Access Compliance Report

Public Rights-of-Way (Curb Ramps)

Intersection ID: 28367	Main Street: SOUTHAMPTON COMMONS DR	Cross Street: TRAVIS GULCH DR	Location: SW
ADA ID: F093FB15A975	Ramp Type: Perp	Initial Pass/Fail: Fail	Overall Compliance: No
Severity Score: 48.75			
Codes/Mitigation Info/Possible Solution		Field Measurements/Component Compliance

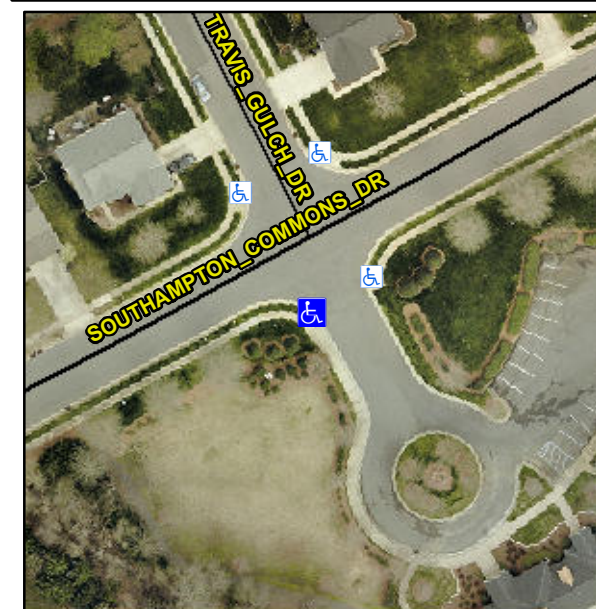
Not Found, R304.5.1, R304.2.2, R304.5.3

Compliance	Description	Data	Compliance	Description	Data
N/A	Ramp Length (in)	48.0	No	Ramp Slope (%)	8.5
No	Ramp Width (in)	29.0	No	Ramp XSlope (%)	4.5
N/A	Flare Type LT	N/A	N/A	Flare Type RT	N/A
N/A	Flare Slope LT (%)	N/A	N/A	Flare Slope RT (%)	N/A
N/A	Flare Traversable LT?	N/A	N/A	Flare Traversable RT?	N/A
N/A	Landing Length (in)	N/A	N/A	DWS Provided?	N/A
N/A	Landing Width (in)	N/A	N/A	DWS Contrast?	N/A
N/A	Landing Slope (%)	N/A	N/A	DWS Length (in)	N/A
N/A	Landing X Slope (%)	N/A	N/A	DWS Full Width?	N/A
N/A	Landing Curb? (Y/N)	N/A	N/A	DWS Offset (in)	N/A
N/A	Shared Landing?	N/A			
N/A	Gutter Ponding?	N/A	N/A	Gutter Slope (%)	N/A
N/A	Gutter Lip Ht (in)	N/A	N/A	Gutter X Slope (%)	N/A
N/A	Painted X Walk1?	No	N/A	Painted X Walk2?	N/A
	X Walk 1 Direction	To E		X Walk 2 Direction	N/A
N/A	X Walk 1 Width (in)	N/A	N/A	X Walk 2 Width (in)	N/A
	X Walk 1 Slope (%)	5.3		X Walk 2 Slope (%)	N/A
	X Walk 1 X Slope (%)	3.4		X Walk 2 X Slope (%)	N/A

Remove & Replace Entire Ramp.
